Sheet: /
File: digital_dash.kicad_sch

Title: Digital Dash

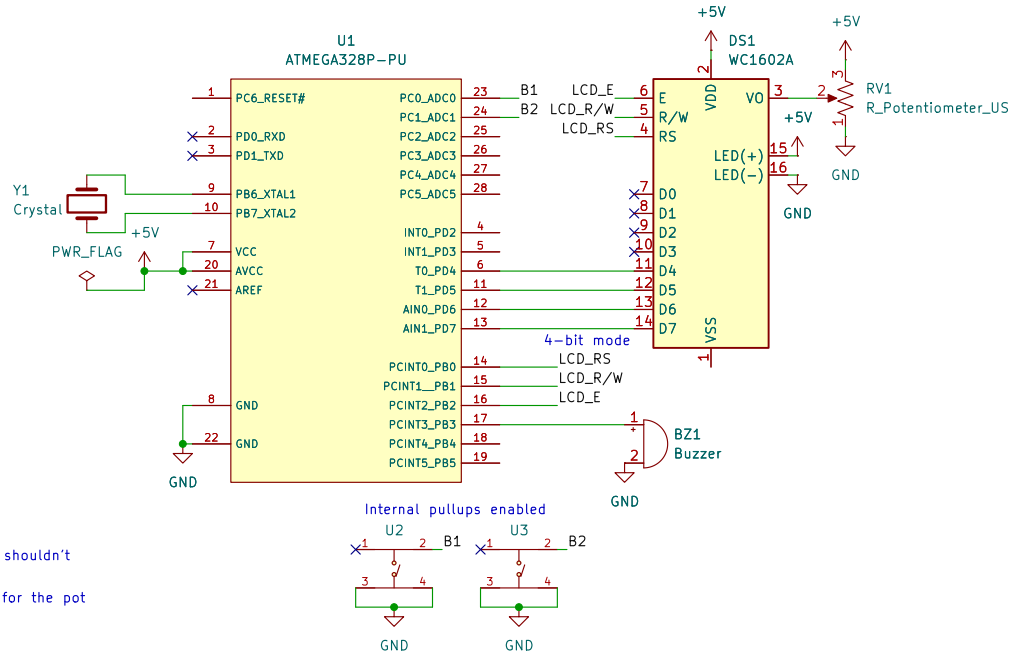
The designator for the push button shouldn't be UX

Double check footprints. Especially for the pot
